Director's Hearing Agenda

Regular Meeting Agenda: May 25, 2023

1. 1095 Forest Avenue: Request for a Director's Hearing on Individual Review Decision

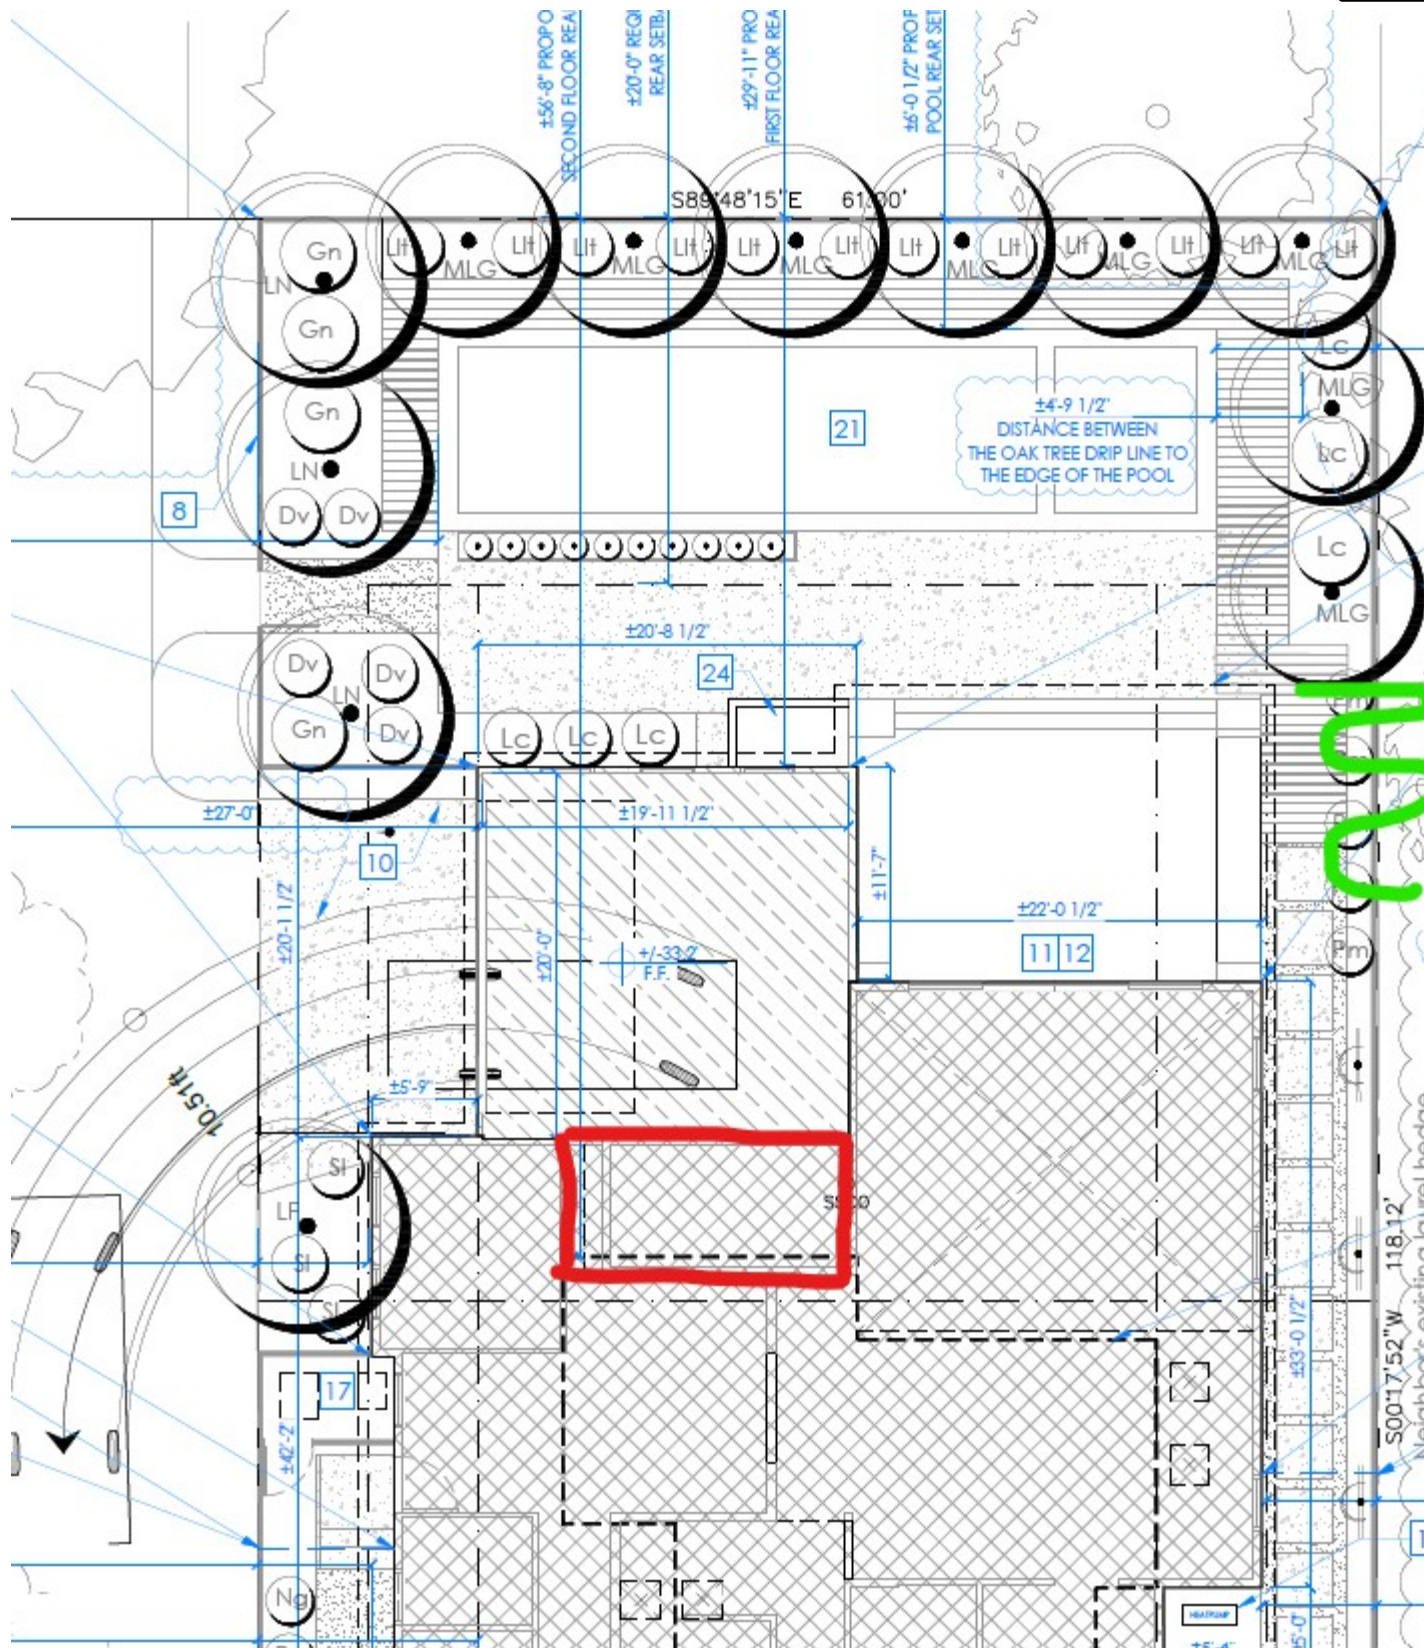
Thanks Emily. Great news on the bathroom windows. Yes, the green area you have marked out is exactly where we have the coverage problem - this is exactly where the balcony will look directly into our yard and pool - it's the spot where our hedge has not grown up/ won't grow, and where the only tree cover is deciduous, and even when green not very heavy cover, and there is still a gap even when those trees have leaves. Thanks

I realized it is slightly unclear on the main site plan where the balcony is in relationship to the landscaping so I added mark ups below:

squiggle is the only spot where there's a combination of lower shrubs and your deciduous landscaping. I do not think it is feasible to add more to this area, particularly when the views are already partially screened.

Thank you for your responses. In the meantime, I confirmed with the architect that obscured glazing can be added to the bathroom windows.

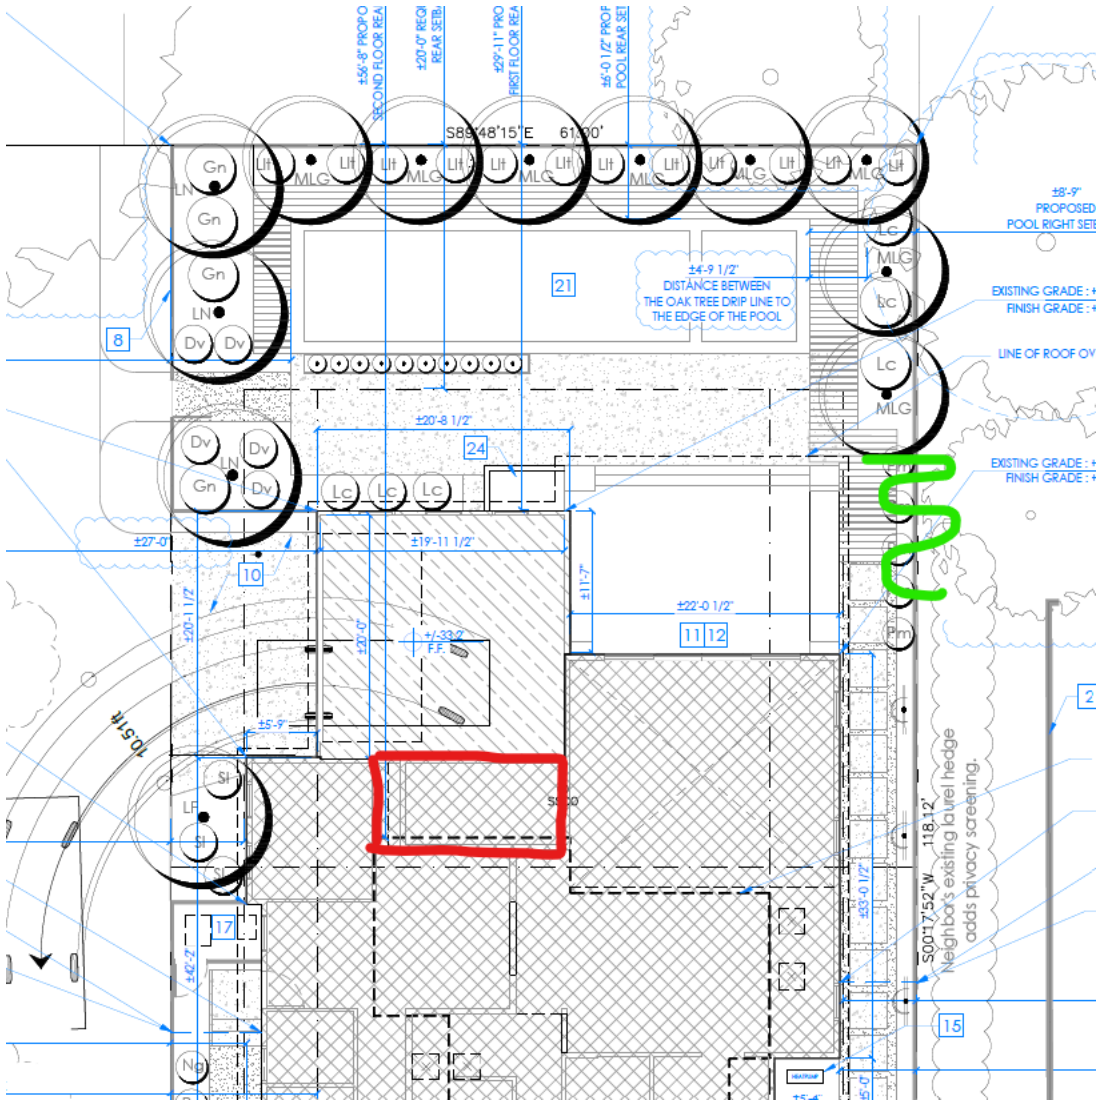
I've marked up the 20' tall tree in the plan below, as you could see, it will be taller than eyesights.

I spoke with the neighbor again and they want taller landscaping planted in the area marked in green below. Do you have any initial thoughts? It may be helpful to get photos of the neighbor's landscaping from your side of the fence.

The Podocarpus macrophyllus is a small tree or large shrub that forms a slender column, 20'-30' tall and 14' wide. Its pointed leaves are dark green in color, with a length of 4" needles. This makes a good hedge, screen, or single specimen plant. It can tolerate low light so Yew Pine is used in malls or narrow areas.

The owner is out of town at this point, but they will provide the photo on the weekend. We could discuss more when we have the photo, thank you.
